T21SA00083

Case Number DDO-21-17

DESIGN DEVELOPMENT OPTION (DDO) APPLICATION For Landscaping/Screening Substitutions

City of Tucson Fire Station 7 - Project Description

1 SITE PLAN
SCALE: 1"=20'-0"

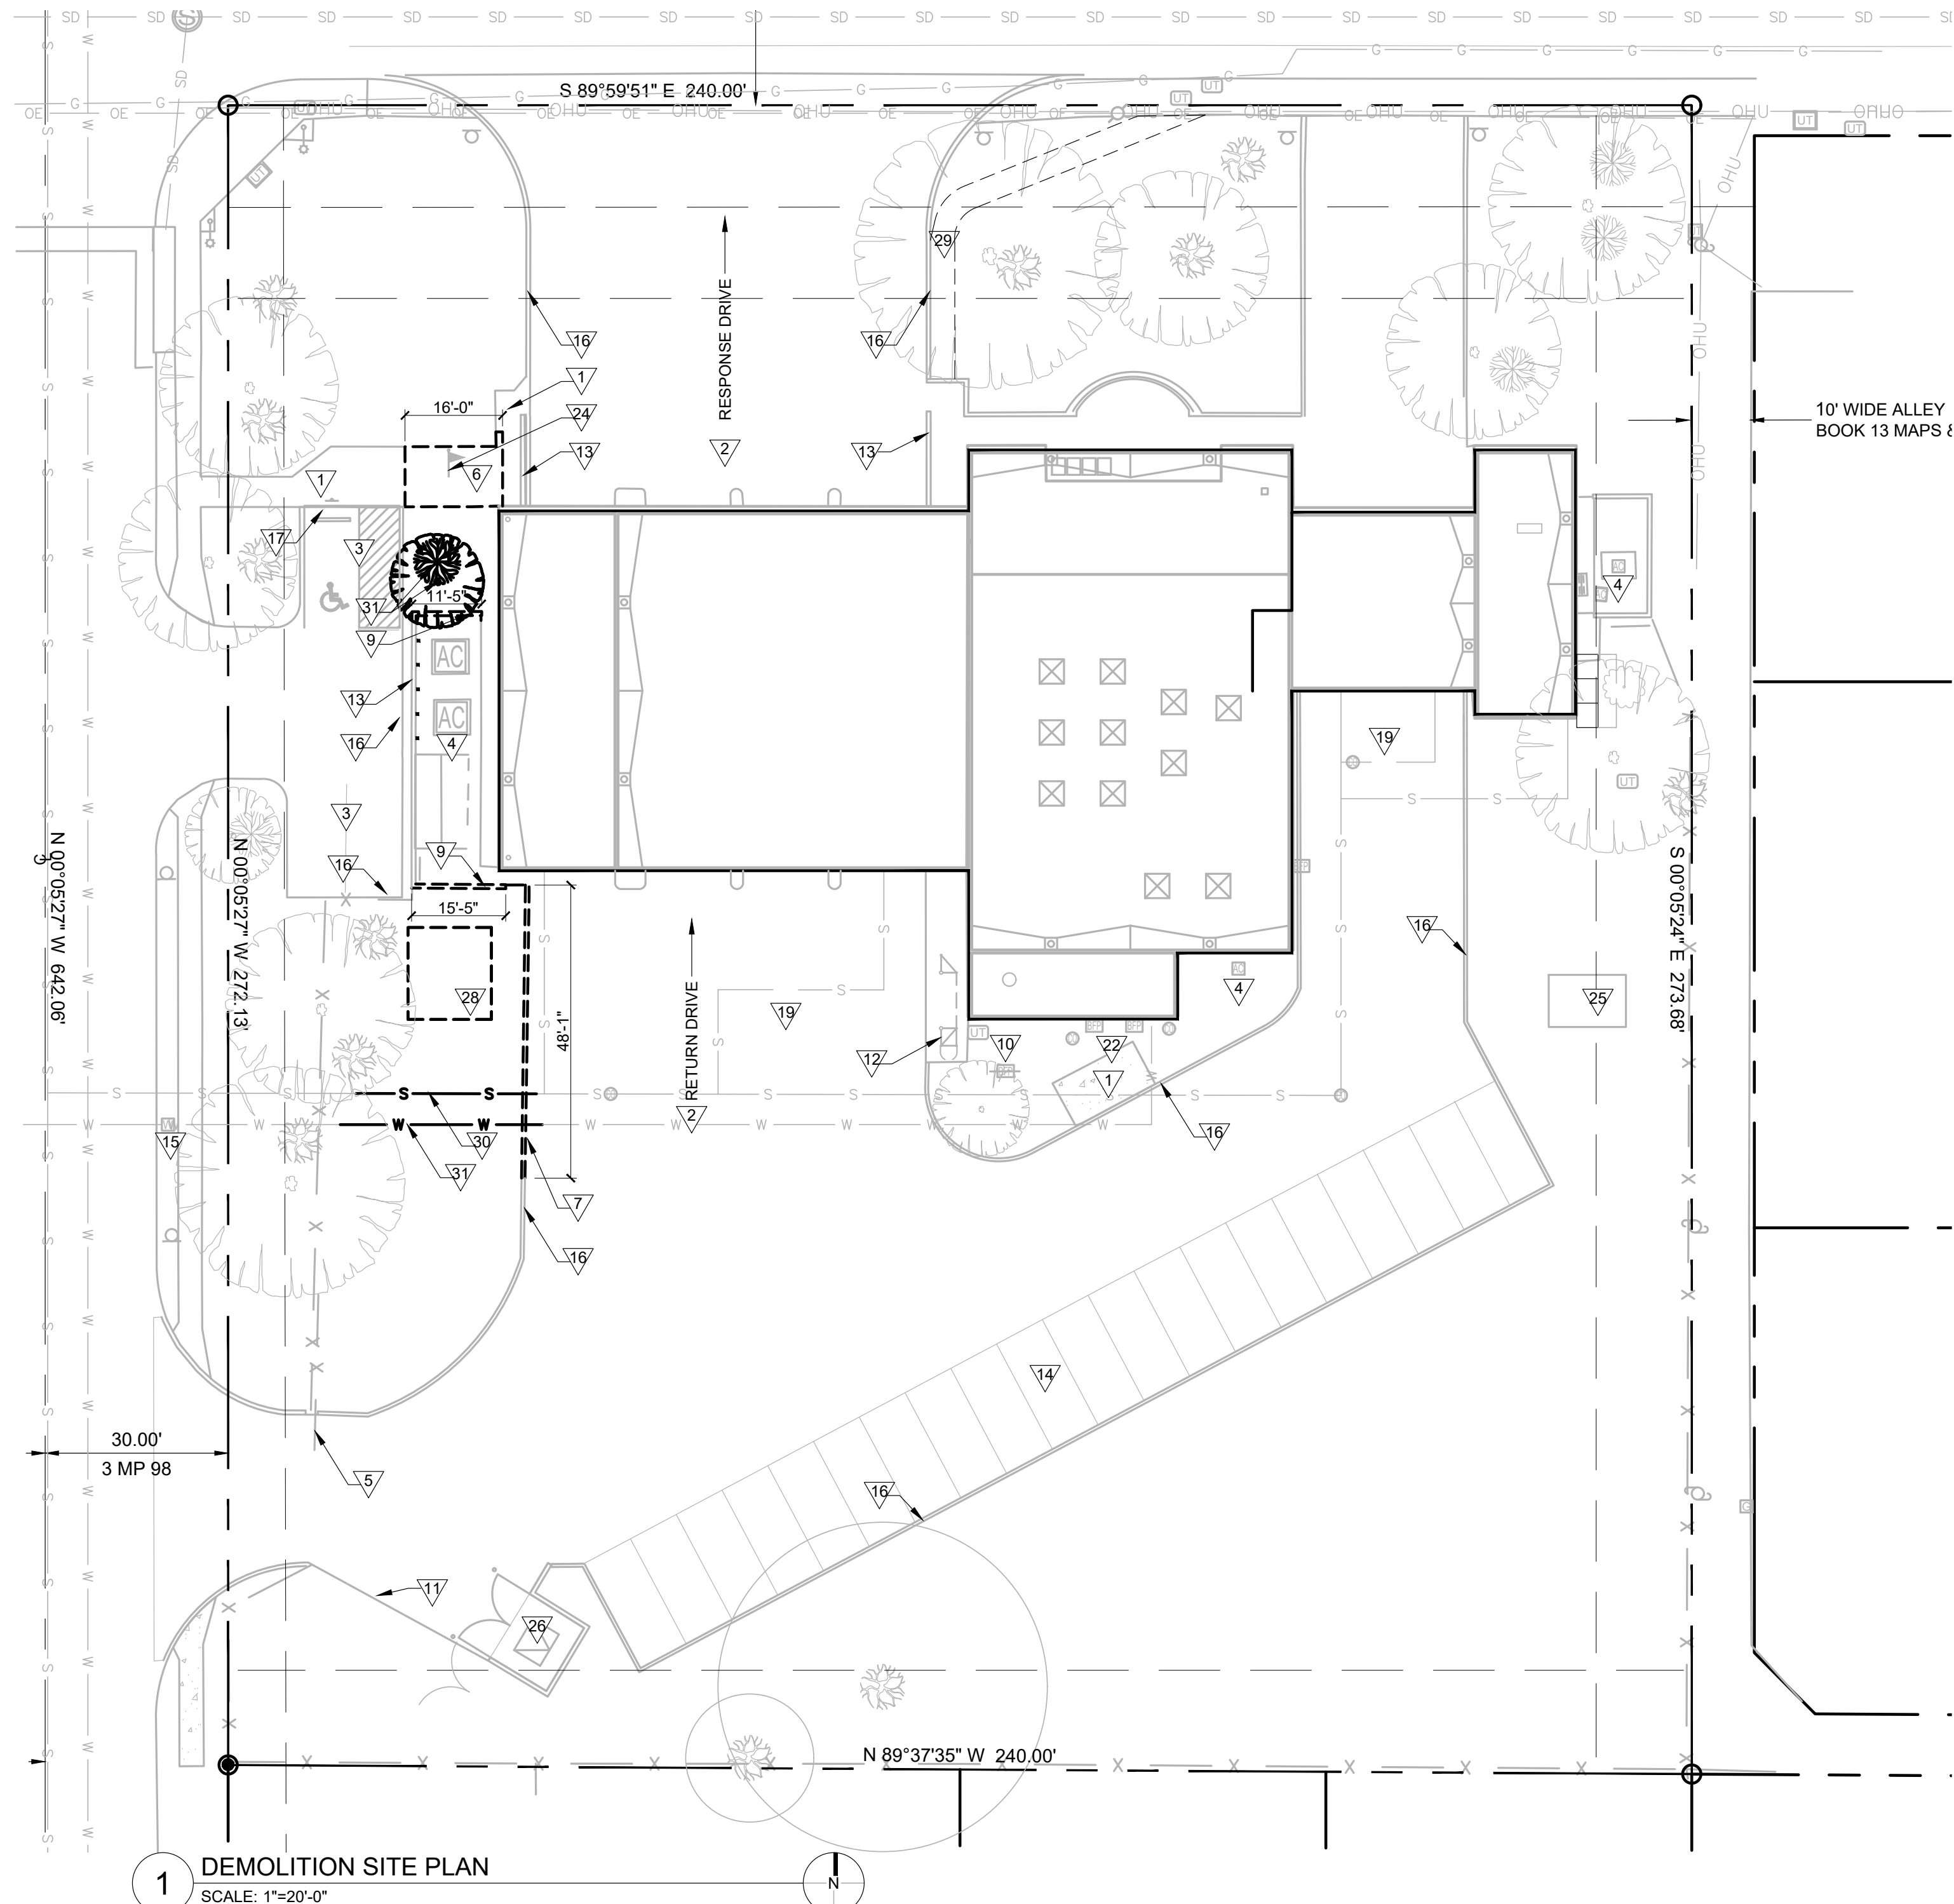
3. 2-06.4.7.A.8.a, b, c – Update general notes on sheet 1. Include existing storage building on east of property, which appears to be approximately 100 sq ft. Update notes on floor area for each building, Percentage and area in square feet of building and accessory building coverage, and Percentage of building, lot area, or vehicular use area expansion.

4. 2-06.4.8.A - Provide site boundary/subdivision perimeter information, including bearing in degrees, minutes, and seconds, with basis for bearing noted, together with distances in feet, to hundredths of a foot, or other functional reference system.

6. 2-06.4.8.C - The following information regarding existing private or public right-of-way adjacent to or within the site shall be provided: the name, right-of-way width, recordation data, type and dimensioned width of paving, curbs, curb cuts, and sidewalks. Include information for Pima St and Arcadia Av on site plan.

7. 2-06.4.9.F - All existing zoning classifications on and adjacent to the project (including across any adjacent right-of-way) shall be indicated on the drawing with zoning boundaries clearly defined.

12. 2-06.4.9.Q - Provide the square footage and the height of each commercial, industrial, or business structure and the specific use proposed within the footprint of the building(s). Provide sq ft and height of existing storage building on east of property.

LANDSCAPE PLAN

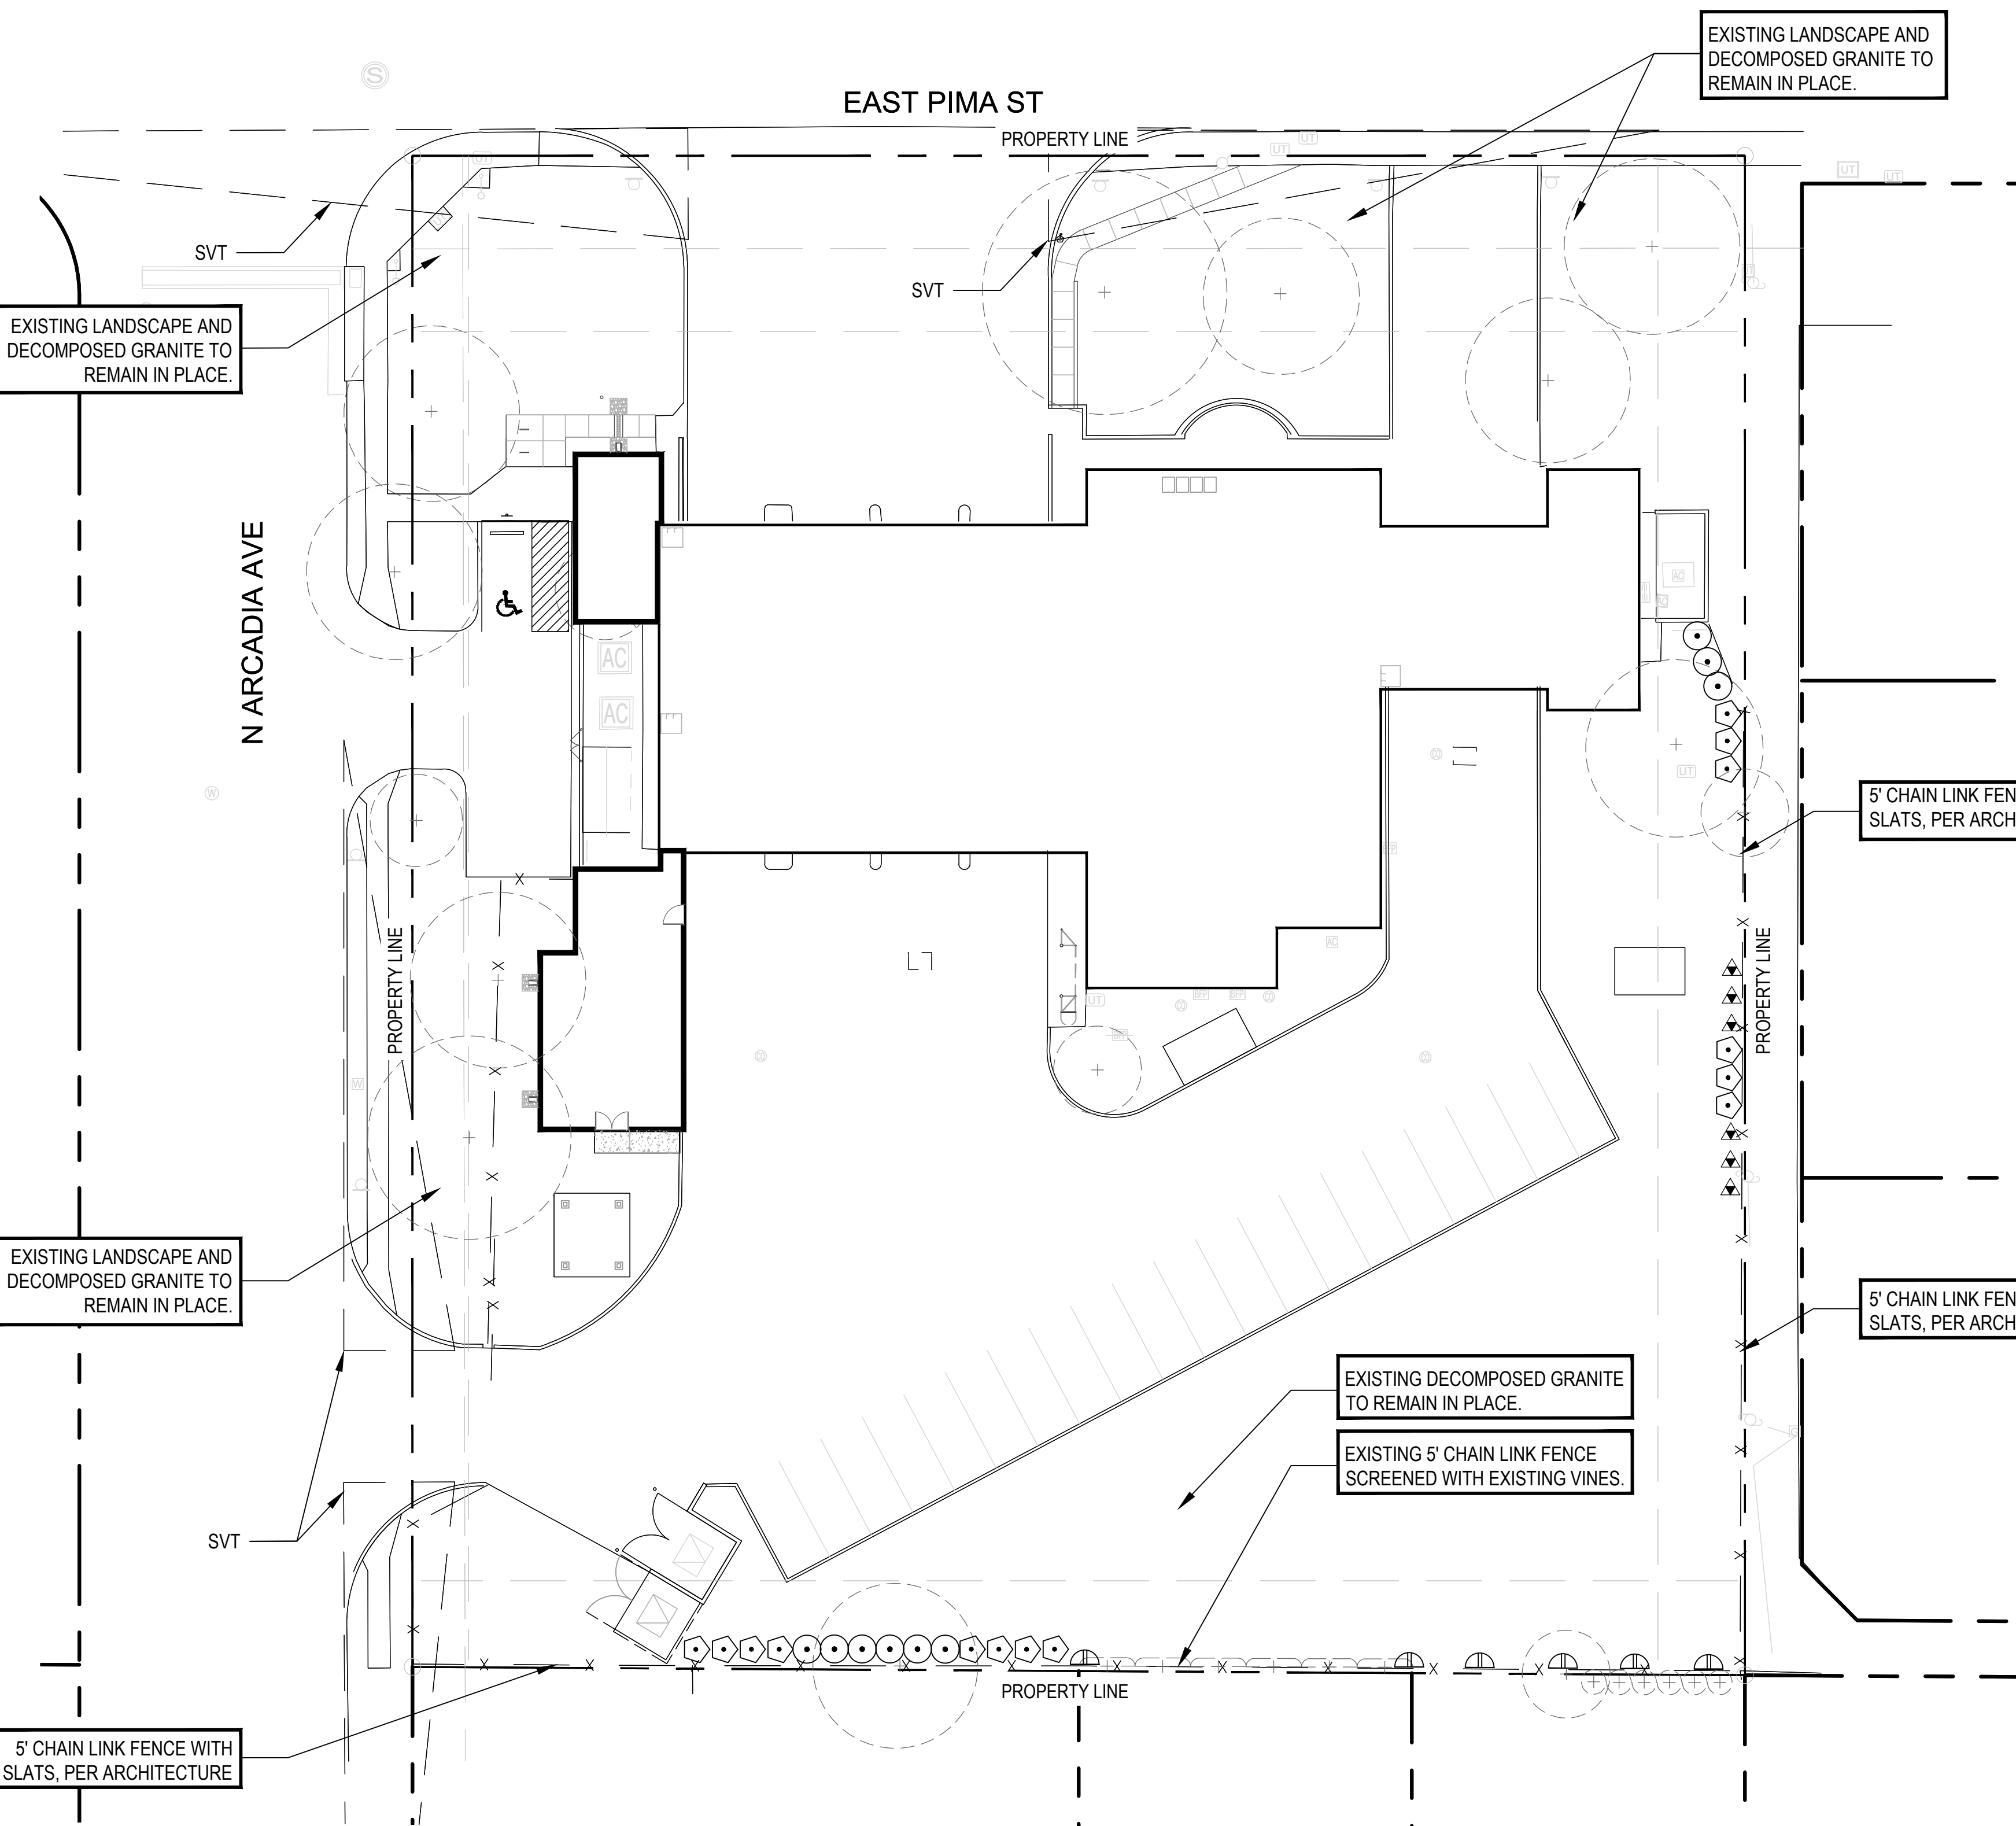
Objective: For the provision of new slats and vegetation in the existing of 6'-0" high chain link fence to the east, and the addition of vines and slats to fill in gaps of visibility at the 6'-0" high chain link fence to the south to be allowed to meet the intent for required screening.

The south and east east property lines have existing chain link fence along the property lines. The east boundary fence abuts an electrical easement and the neighboring residential properties have existing masonry site walls. We wish to add slats to this portion of existing chain link fence, and add vegetation in some areas to meet the intent for opaque screening. The south boundary fence has varied vegetative coverage, including dense vines over the chain link that come from either side of the property line. There are also areas of abutting fence material on adjacent property side. We wish to preserve the existing vegetation in place to act as screening, and supplement with additional plant coverage and slatting where there are open 'gaps' of visibility. We believe that these conditions will provide adequate screening from the adjacent residential properties that meet the intent for opaque screening.

Our objective in this DDO request is for a substitute of materials to meet the intent of the use specific standard for opaque screening between the Fire Station and residential-zoned properties. We request to provide new slats and vegetation in the existing 6'-0" high chain link fence to the east and provide new slats and vegetation to fill in gaps of visibility at the existing 6'-0" high chain link fence to the south to be allowed to meet the intent for required screening.
